**City of Bellevue  
Development Services Department  
Land Use Staff Report**

**Proposal Name:** Woxland Slope Buffer Modification

**Proposal Description:** Land Use review of a proposal to reduce the 50-foot top-of-slope buffer and replace an existing rockery at the top-of-slope of a steep slope critical area.

**File Number:** 10-113250-LO

Figure 1

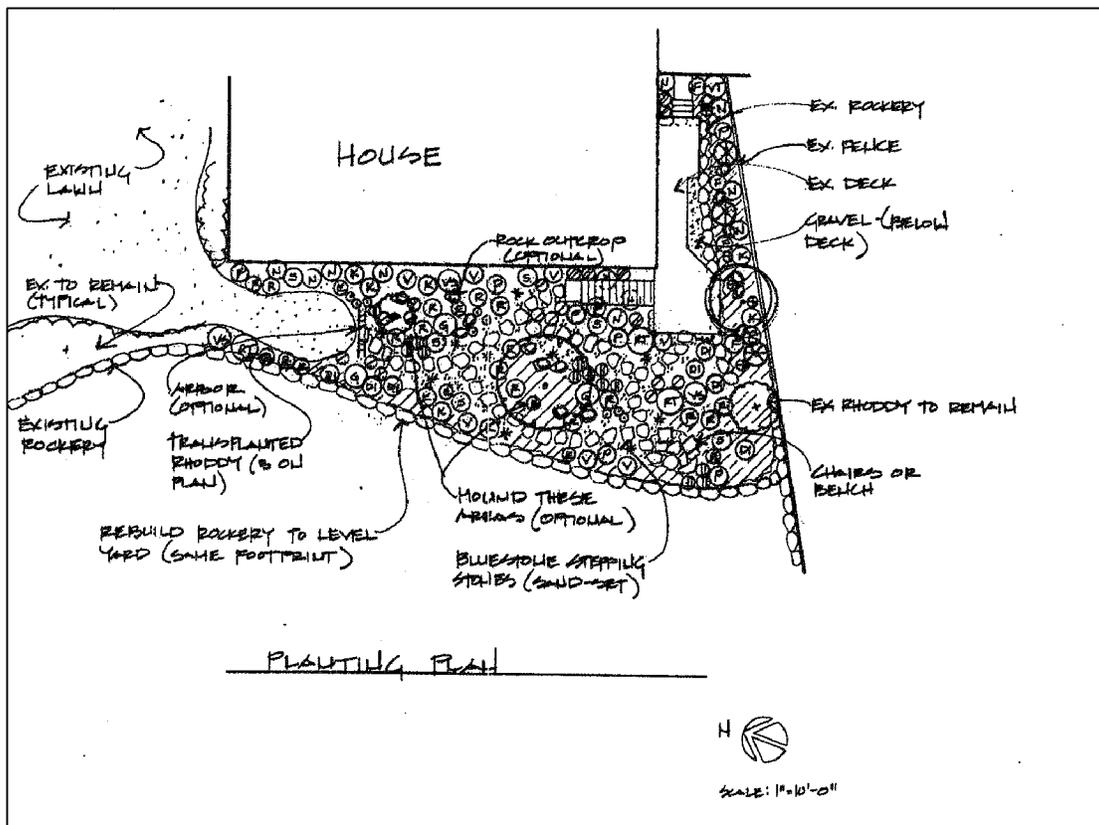
The applicant proposes to replace an existing rockery and reduce the 50-foot top-of-slope buffer to the rockery which is located at the top-of-slope. This will allow the applicant to make landscape changes and use this area of their property. This application is associated with a code enforcement action (10-109938-EA) for work without a permit in the buffer. A Critical Areas Land Use Permit is required to approve a reduction of a top-of-slope buffer. See Figure 1 below for a site plan showing the proposed activities.
